10/563,257

<b>Office Action Summary</b>	<b>Application No.</b> 10/563,257	<b>Applicant(s)</b> NEUMANN, CHRISTIAN	
	<b>Examiner</b> Charles E. Cooley	<b>Art Unit</b> 1797

## **FINAL OFFICE ACTION**

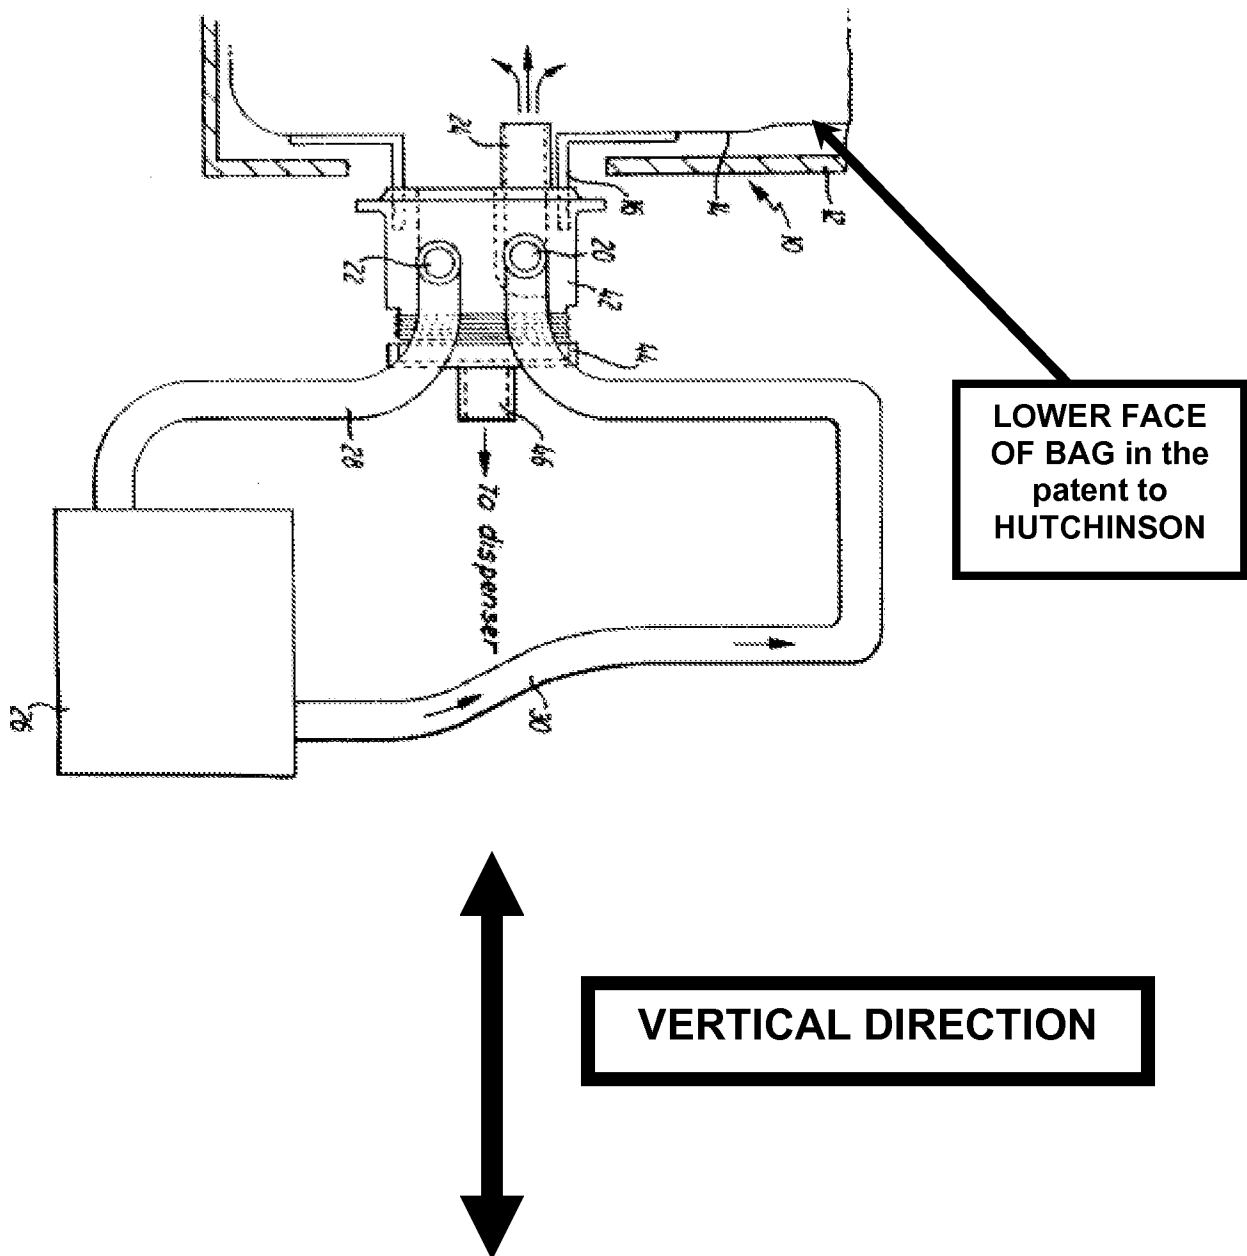
The patent to Hutchinson discloses a system and method including a rigid container 12; peristaltic pump 26 connected to external mixing duct 18, 28; a bag 14; the lower face of the bag 14 includes an orifice 16 for the liquid to discharge to the outside of the bag (as illustrated below); the bottom of the container 12 is fitted with an elongated slit (about 16 - Fig. 1) allowing the insertion and the passage of the mixing duct 18, 28. It would have been obvious and mere common sense to one having ordinary skill in the art, at the time applicant's invention was made, to have provided the lower face of the bag in Stewart with an orifice for the liquid to discharge to the outside of the bag and the bottom of the container with an elongated slit allowing the insertion and the passage of the mixing duct for the purposes of dispersing the solid particles that have settled in the bottom of the bag back into the liquid in the bag (col. 1, lines 11-15 and col. 2, lines 23-34).

With regard to the combination of STEWART and HUTCHINSON, the examiner in fact asserted in the last office action that the lower face of the bag 14 in Hutchinson included an orifice 16 for discharge of the liquid (Fig. 1 of Hutchinson). The examiner has further emphasized this aspect by the annotated Figure 1 of Hutchinson above explicitly showing an orientation wherein the orifice 16 is located in the lower face of the bag. However, Applicant argues that the orifice 16 is on a lateral (side) surface of the bag (p. 15 of the response).

While it is agreed that Hutchinson shows in Fig. 1 the apparatus shifted 90 degrees from the manner in which the examiner has interpreted this reference, turning a prior art apparatus by such a shift does not result in a different device. The orientation of a claimed apparatus with respect to an object which is not part of the claimed structure, such as the surface of the Earth, is not germane to the patentability of the apparatus itself, but instant relates to the in manner in which the apparatus is used. Applicant has not identified any structural difference between the claimed lower face of the bag with an orifice and Hutchinson's lower bag face with an orifice. The only distinction to which Applicant can aver is a difference in the location or orientation of the bag during use, and it is well settled that an intended use does not render the claimed apparatus
